UNITED STATES  
DEPARTMENT OF THE INTERIOR  
BUREAU OF LAND MANAGEMENT  
SUNDRY NOTICES AND REPORTS ON WELLS

5. Lease Serial No. <b>NMNM69596</b>
6. If Indian, Allottee or Tribe Name
7. Unit or CA Agreement Name and No. <b>Nm 94480 A</b>
8. Well Name and No. <b>GAUCHO UNIT 5</b>
9. API Well No. <b>30-025-34149</b>
10. Field and Pool, or Exploratory <b>OJO CHISO</b>
12. County or Parish 13. State <b>LEA NM</b>

**PROPOSED PLUG & ABANDONMENT**

**Gaucha Unit 5**  
**Devon Energy Production Company, LP**  
**April 11, 2007**  
**Plug and Abandonment Procedure**  
**Conditions of Approval**

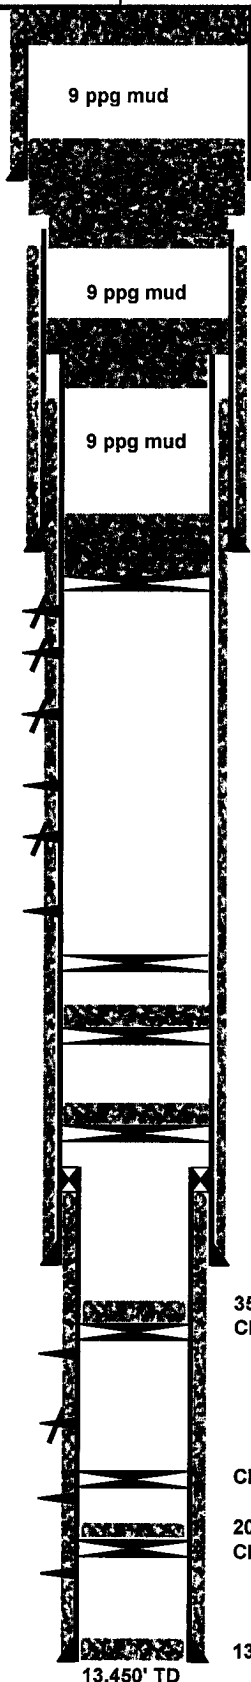
1. 70' cement is adequate if bailed, but if it is placed with tubing – it must be 25 sacks or 100 feet, whichever is greater. This plug must be tagged.
2. NMOCD requires 9.5 ppg brine with 12.5 pounds of gel per barrel.
3. Ok
4. Plug to be a minimum of 25 sacks and a minimum of 100' plus 10% slurry for each 1000 feet of depth (40% extra slurry).
5. Ok
6. If plug not at 50 feet above casing shoe, pump additional cement and tag.
7. Ok
8. Ok

Proposed:  
 1. Set cement plug from 60' to surface.

Proposed:  
 1. Cut 9-5/8" casing +/- 2400' & POOH. Set 215' stub plug. Tag. (note: TOC on 9-5/8" annulus @ 2460' based on temp survey)

Proposed:  
 1. Cut 7" casing +/- 4100' & POOH. Set 100' stub plug. Tag. (note: TOC on 7" annulus @ 4150' based on CBL from cement sqz @ 5320')

Proposed:  
 1. Spot 70' cement on top of existing CIBP @ 5200'.  
 2. Circulate hole w/9# mud from TOC to surface.
